Inc. Village of Woodsburgh

APPLICATION DENIAL LETTER

Re: 110 Wood Lane, Woodsburgh; SBL 41-68-275; Denial Letter

FISHMAN RESIDENCE

PLOT PLAN

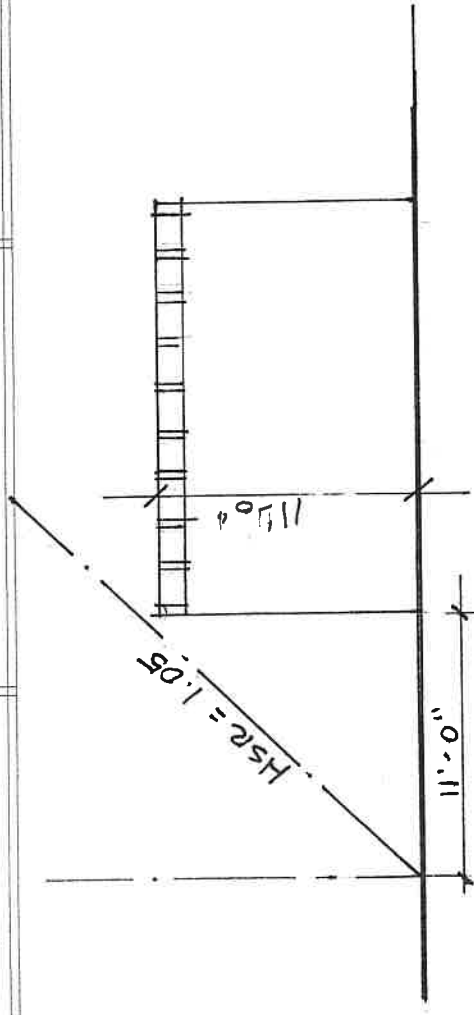
1. **Section 150-9 Rear Yard.** The rear yard shall be 25 feet.
 - a. Proposed Pergola 1 has a rear yard setback of 21 feet, where 25 feet is required.
2. **Section 150-11 Side Yard.** The side yard shall be 20 feet.

- a. Proposed Pergola 2 has a side yard setback of 11 feet, where 20 feet is required.
3. **Section 150-39(A)** The areas occupied by all buildings and structures and accessory uses which extend above the grade of the property shall not exceed 15% or 3,422.55 square feet of a lot size of 22,817 square feet.

- a. Proposed lot coverage is 21.5% or 4,904 square feet.
4. **Section 150-39(E).** Accessory buildings and structures not greater than 100 square feet in floor area and not more than 10 feet in height measured to the highest point of the building or structure shall be located not closer than 1/3 of the side yard and rear yard dimensions applicable in the district in which the lot is located. Accessory buildings and structures are not permitted in a front yard.

- a. Proposed are 4 entry piers with gates located in the front yard, where no accessory structures are permitted in a front yard.

- b. Proposed north entry pier has a side yard setback of 6 inches, where 13.32 feet is required.
- c. Proposed south entry pier has a side yard setback of 3 feet, where 13.32 feet is required.

An updated application to the zoning board is required and the new legal notice must be mailed out certified return receipt to the properties within the 300-foot radius.
